LAND EAST OF TYE LANE,

WALBERTON

DESIGNERS RESPONSE – STAGE 1 ROAD SAFETY AUDIT

REPORT REF NO. 183248-03

Drawing Title:
**PROPOSED ACCESS IMPROVEMENTS
- TYE LANE/AVISFORD PARK ROAD**

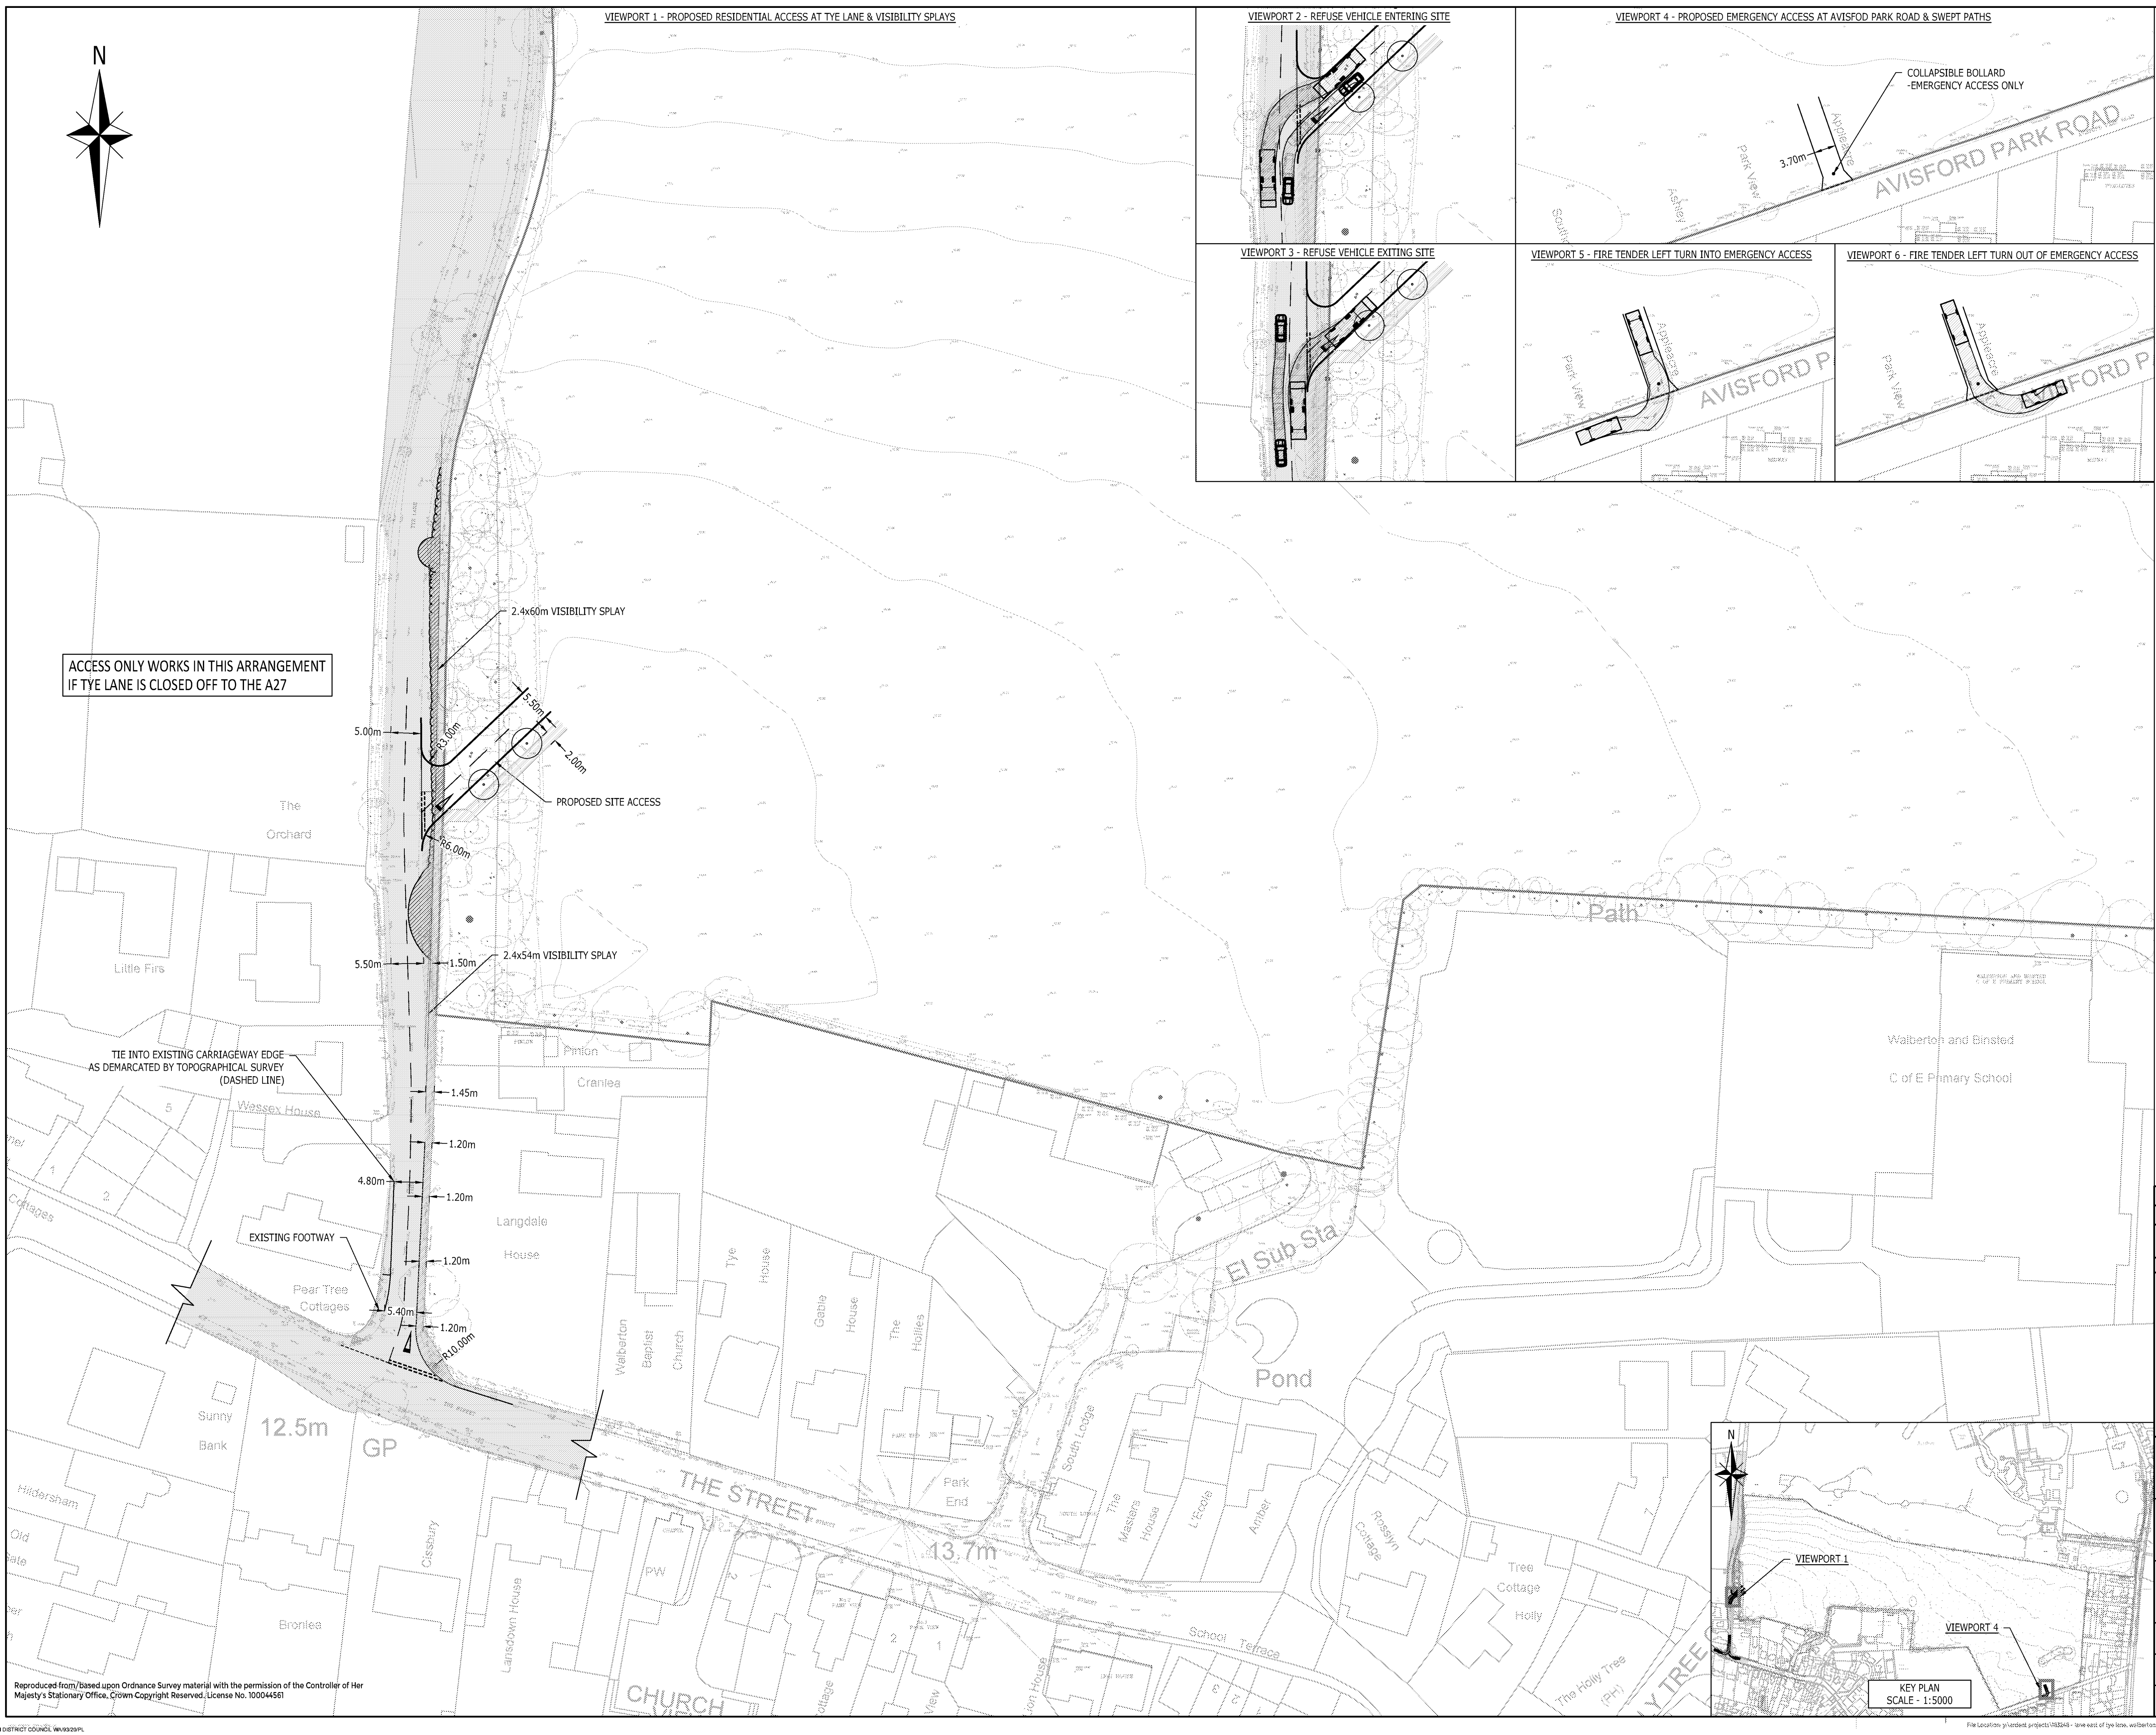
RSA problem	RSA recommendation	Design organisation response	Overseeing Organisation response	Agreed RSA action
Poor visibility may lead to accidents	It is recommended that the visibility splay is increased sufficiently to allow all southbound vehicles to see the proposed access at the speed limit.	We do not agree with the Auditor comments. To confirm visibility splays incorporated into the preliminary design were based upon the findings of traffic surveys adopting 85th percentile speeds as appropriate. This is clarified within Note 1 of the drawing and is also shown on the revised and updated access design in ACE Drawing 183248-002C. It should be noted, and is clarified on ACE Drawing 183248-002C, that use of the access junction with Tye Lane would only come into effect should the A27 Bypass proposals be implemented. In the scenario where the Bypass is implemented the northern end of Tye Lane would be stopped up and hence vehicle traffic flows would be substantially reduced from those measured by the survey. Given the visibility splays extend to the requirements of measured speeds, and that the northern end of Tye Lane will be closed in the future, the visibility splays as shown demonstrate safe egress is possible.	Visibility splays are to be provided in line with the existing recorded 85th % speeds. The approach was acceptable to WSCC in relation to the emergency access that forms part of the original application on the site. The access (to allow all vehicles) would also only be implemented should the A27 Arundel bypass be constructed and Tye Lane stopped up to the north of the site access.	Visibility splays will be provided in accordance with recorded 85 th % speeds.

Location: North of the proposed access.

Summary: Poor visibility may lead to accidents.

The Audit Team noted that the proposed visibility splay to the north of the access is 2.4m x 60.0m and the speed limit changes approximately 10m north of the proposed access to the NSL of 60mph. The Audit Team have assumed that the visibility splay is based on a speed survey but there are concerns that traffic speeds for traffic travelling south may be higher at times. If traffic speeds increase the likelihood of collisions at the proposed access may increase.

It is recommended that the visibility splay is increased sufficiently to allow all southbound vehicles to see the proposed access while travelling at the speed limit.

Inadequate footway width may lead to accidents	It is recommended that the width of the footway is increased to a minimum of 1.5m throughout its length.	We do not agree with the Auditor comments. Inclusive Mobility (DfT, 2005) allows a minimum footway width of 1m in certain areas that suffer from constrained space. Nevertheless, ACE Drawing 183248-002C, incorporates further footway widening to provide a minimum 1.2m width along the narrowest section, also providing a wider footway for a longer stretch of the route too. It should be further noted that there is a further pedestrian access point available to prospective occupiers that links to an existing Public Right of Way. The alternative pedestrian connection is provided by way of a pedestrian/cycle access that can also serve as a point of access in an emergency, and can be seen in Viewport 4 of ACE Drawing 183248-002C. Further, the access point and use of the proposed widened footway would only come into use should the Bypass be implemented and hence the northern end of Tye Lane closed. This would result in a significant reduction in vehicle traffic along Tye Lane and the likelihood that a pedestrian pushing a pram met not only another pedestrian but also a vehicle travelling along Tye Lane all at the same time would be negligible. In light of this the proposed widened footway is considered to safely accommodate the likely pedestrian footfall in the context of anticipated vehicle traffic, and will be supplemented by an alternative pedestrian connection, is suitable to serve the needs of the development.	It is acknowledged that the footway to be provided is below 1.5m for approximately 50m, with approximately 25m being 1.2m. The footway would also only be implemented should the A27 Arundel bypass be constructed and Tye Lane stopped up to the north of the site access which would reduce the number of vehicle trips along Tye Lane. Alternative pedestrian and cycle access to the site within the current planning consent already provides a route onto Avisford Park Road and a link onto the Walberton playing fields enabling access to the primary school.	Footways as proposed on ACE Drawing 183248-002C will be provided should the access design be implemented as a result of the Bypass of the A27.

Location: South of the proposed access.

Summary: Inadequate footway width may lead to accidents.

The Audit Team noted that the width of the proposed footway between the proposed access and the existing footway at The Street varies throughout its length and part of it is only 1.0m in width. A footway of 1.0m width is not wide enough to allow a pedestrian pushing a pram to pass another pedestrian without causing them to walk in the carriageway which could lead to vehicle/pedestrian conflicts.

It is recommended that the width of the footway is increased to a minimum of 1.5m throughout its length.
